KELLY AFB
TEXAS

DRAFT MEETING MINUTES

**KELLY AFB TECHNICAL REVIEW SUBCOMMITTEE (TRS)
TO THE RESTORATION ADVISORY BOARD (RAB)**

14 August 2001, Las Palmas Library
515 Castroville Road
Dr. Gene Lené, TRS Chairman

3) Maximum Contaminant Level (MCL) means the most amount of chemical allowed in drinking water as determined by the Environmental Protection Agency. The MCL for Benzene is 5 parts per billion (ppb). The shallow groundwater is not typically used for drinking near former Kelly Force Base.

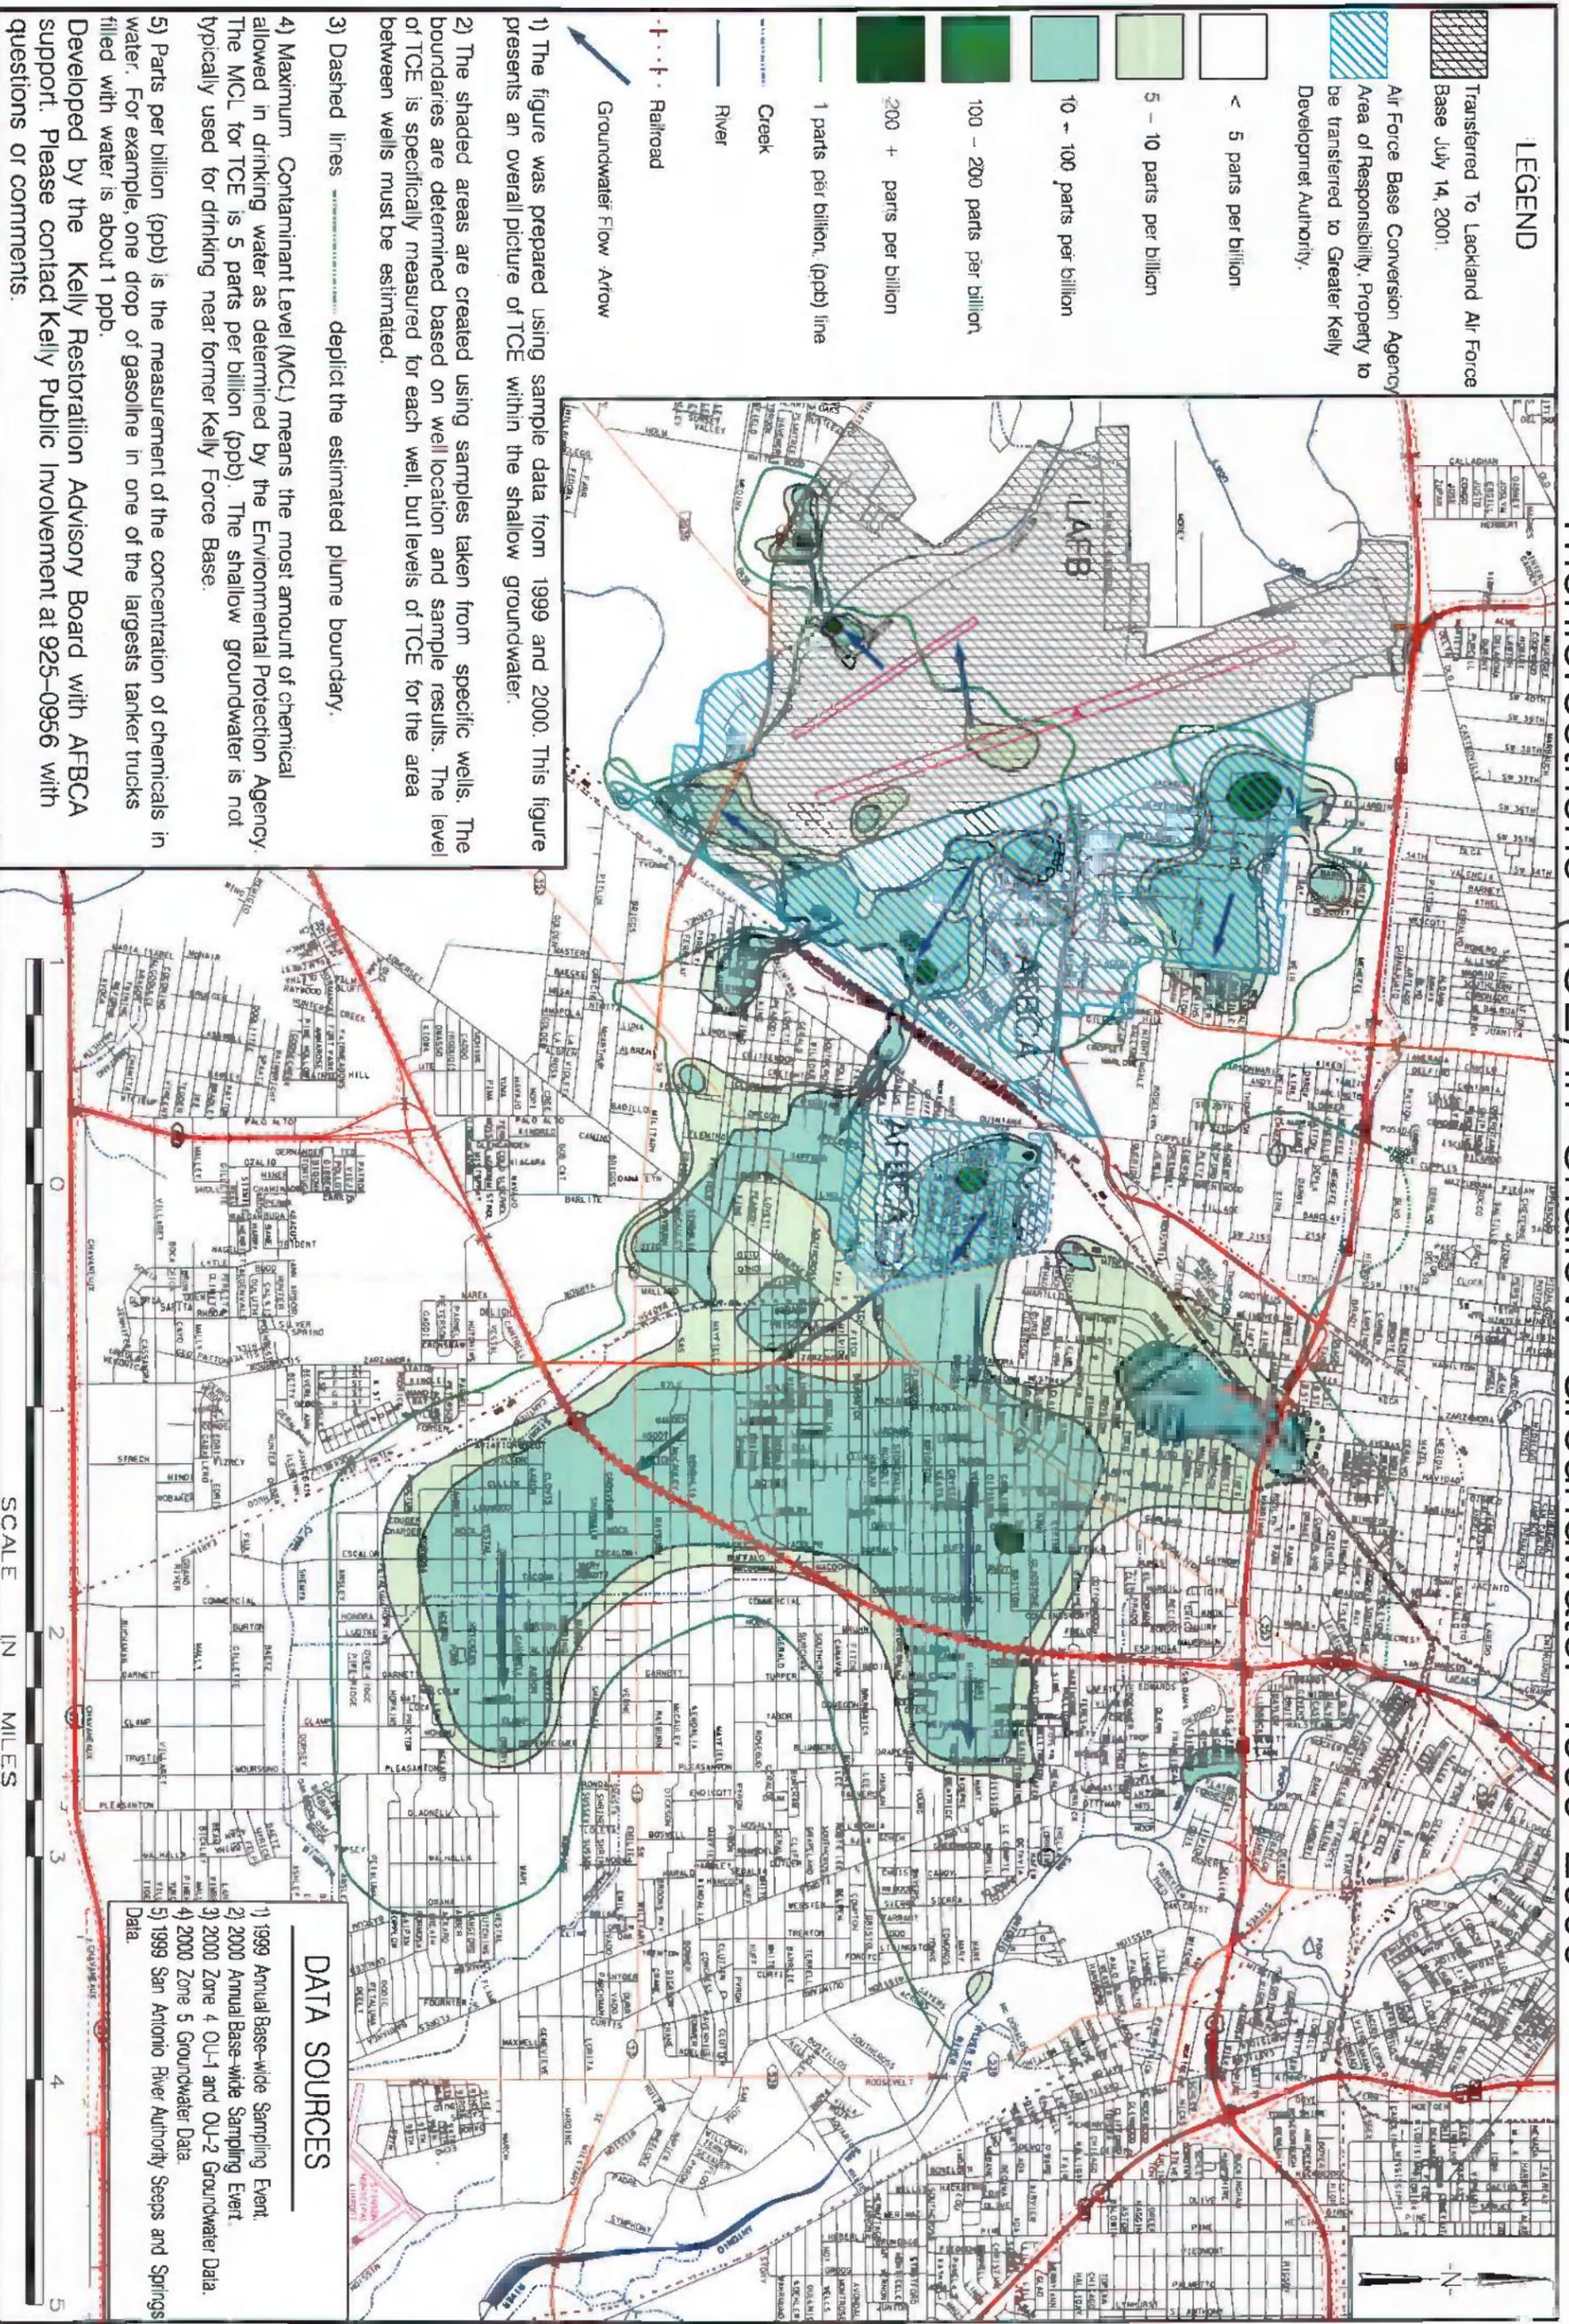
- The dashed green lines on the TCE map should match – make estimated lines the same style
- Replace “typically” with “known to be” in the last sentence of paragraph 4 in each map
- Fix typos on all three maps
- Change the explanation of ppb from the gasoline tanker example to the Olympic swimming pool example
- Change the term “shaded areas” to “contoured areas” in paragraph two of all three maps
- Place the words “for example” in front of the second line in paragraph two of the Metals map
